Springs Preserve Events Plaza

CITY OF LAS VEGAS		DATE: Revision
INTER-OFFICE MEMORANDUM		July 1, 2020
TO: Land Development Services Department of Building & Safety		FROM: Albert Sung, P.E. Flood Control Project Engineer Department of Public Works
SUBJECT:	Drainage Study for:	
	Springs Preserve Events Plaza (Springs Preserve Butterfly Playground)	
Cross Streets:	NEQ of Alta Drive & Valley View Boulevard	Lochsa Engineering
File Number:	F:\Depot\DSMemos\DS5285A-Rev.doc	Bart Anderson, P.E., DevCo
Parcel Number:	139-31-602-003	
Zoning Action:	Site Specific SDR not required	
FEMA Flood Zone	YES NO X	
Proposed Storm Drain	YES NO X

CITY OF LAS VEGAS		DATE:
INTER-OFFICE MEMORANDUM		June 9, 2020
TO: Land Development Services Department of Building & Safety		FROM: Albert Sung, P.E. Flood Control Project Engineer Department of Public Works
SUBJECT:	Drainage Study for:	COPIES TO:
	Springs Preserve Events Plaza (Springs Preserve Butterfly Playground)	Las Vegas Valley Water District
Cross Streets:	NEQ of Alta Drive & Valley View Boulevard	Lochsa Engineering
File Number:	F:\Depot\DSMemos\DS5285A.doc	Bart Anderson, P.E., DevCo
Parcel Number:	139-31-602-003	
Zoning Action:	SDR-XXXXX	
FEMA Flood Zo

DRAWING NUMBER C4
SHEET 6 OF 41

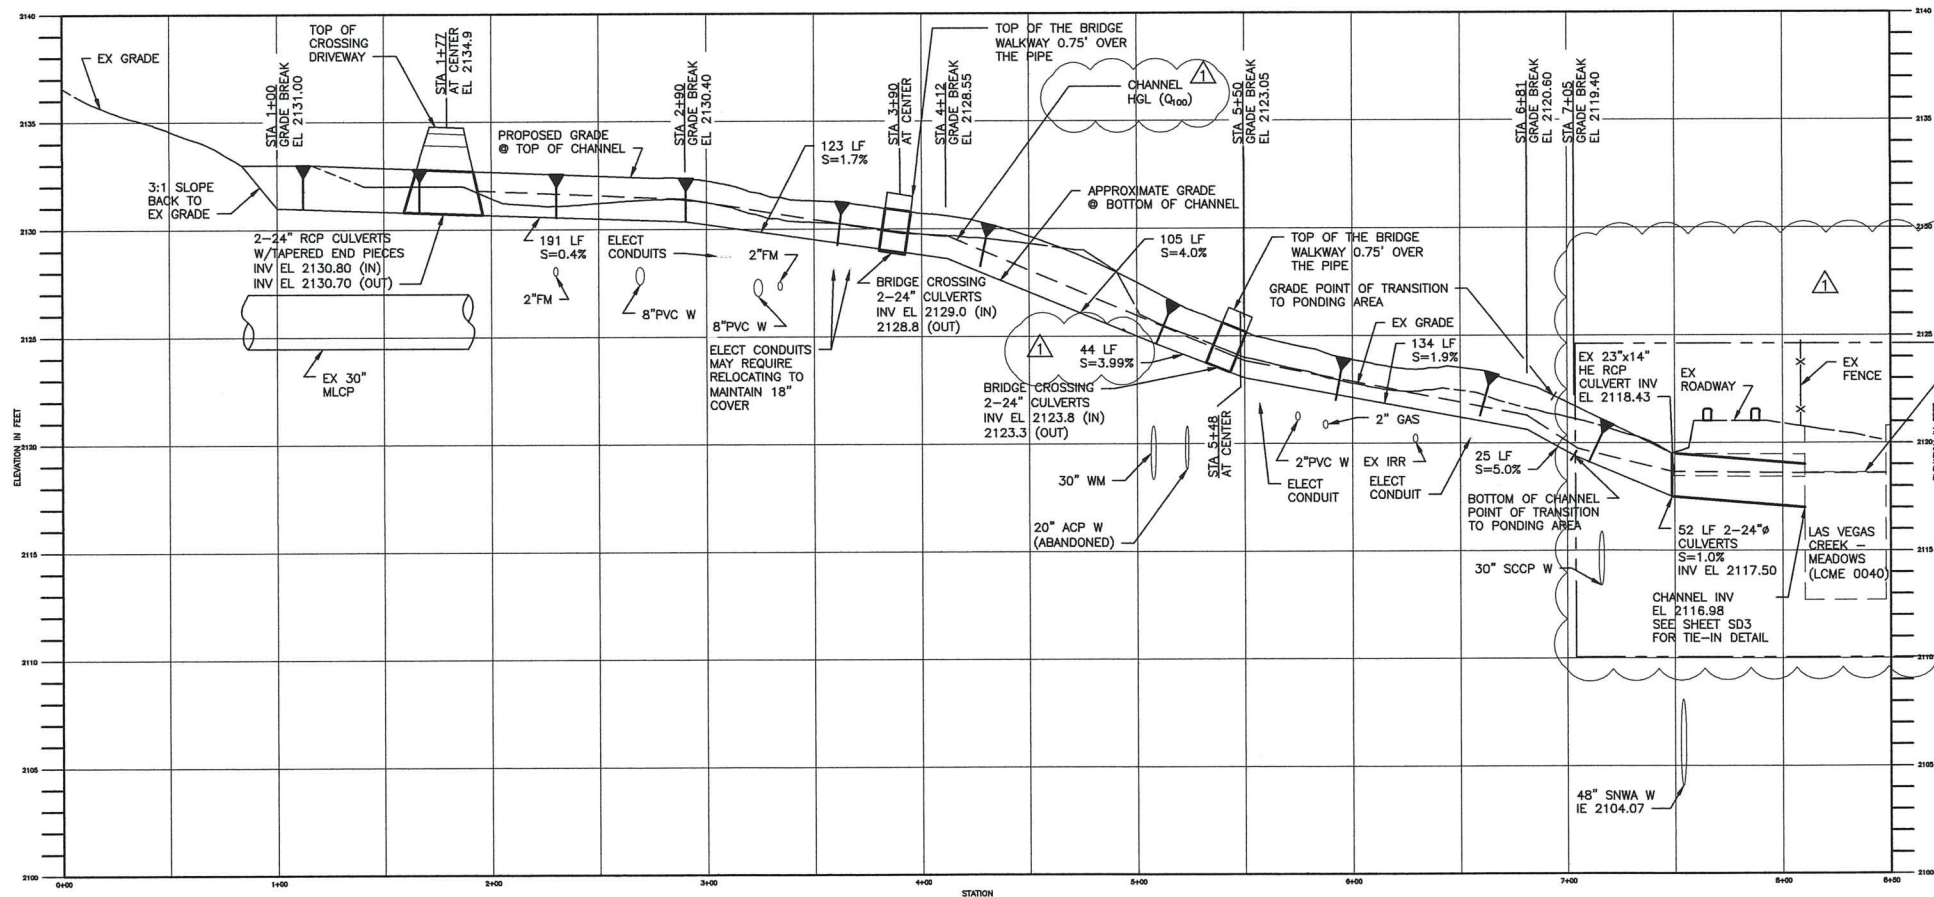
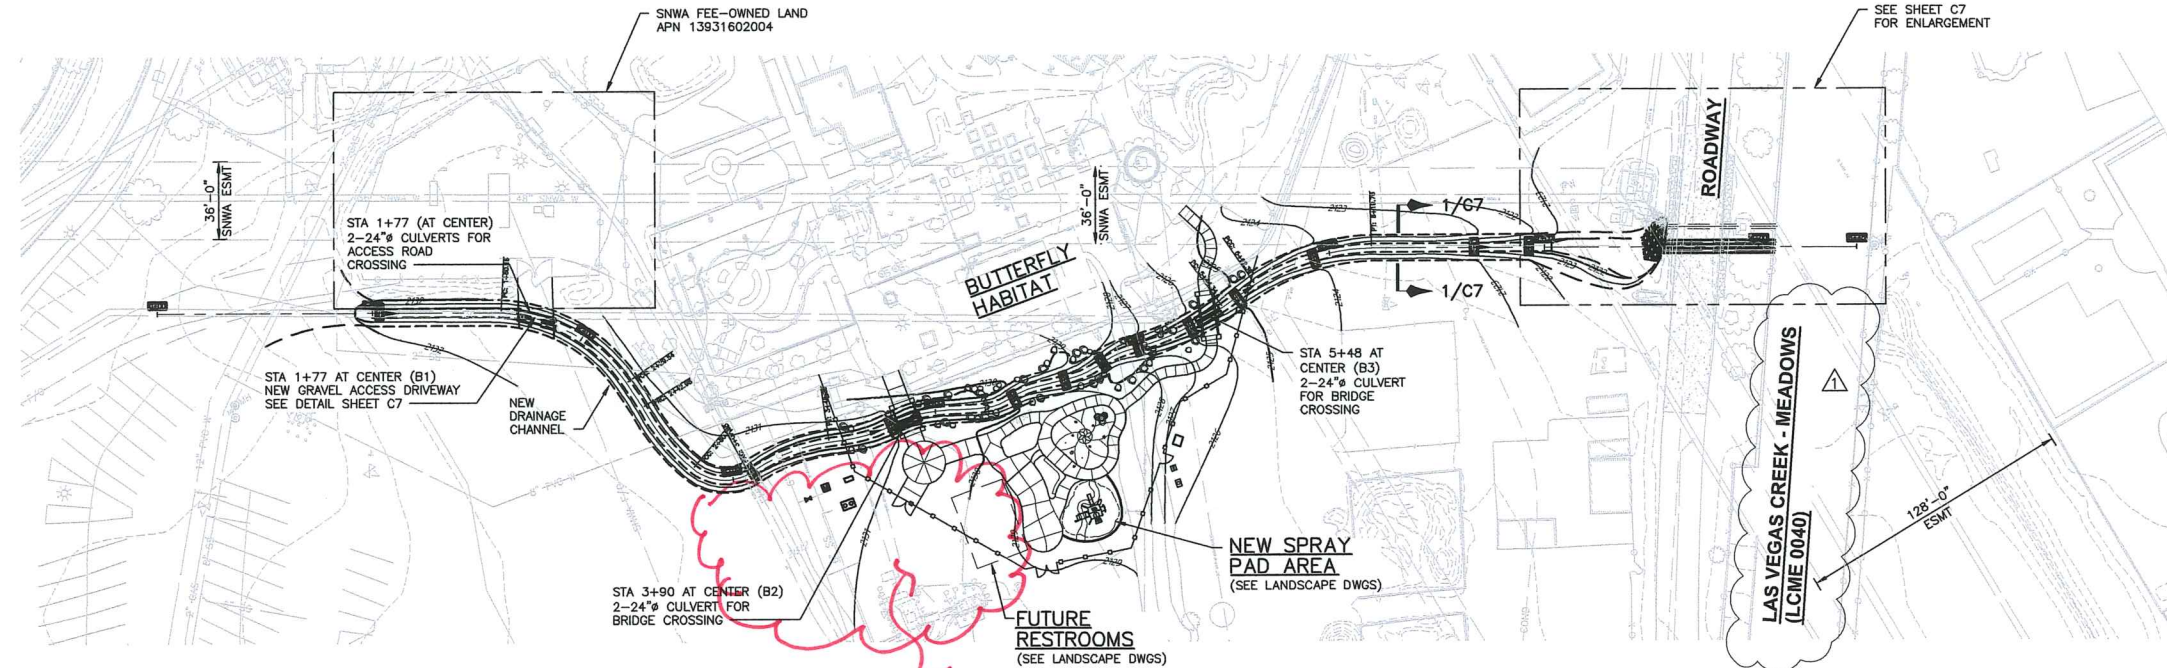
- b. Coordinate with the City of Las Vegas and provide hydraulic analysis to model impacts of the mainline channel. The water surface elevation should be shown on the profile sheet.

The HGL has been added to the profile, see sheet C4.
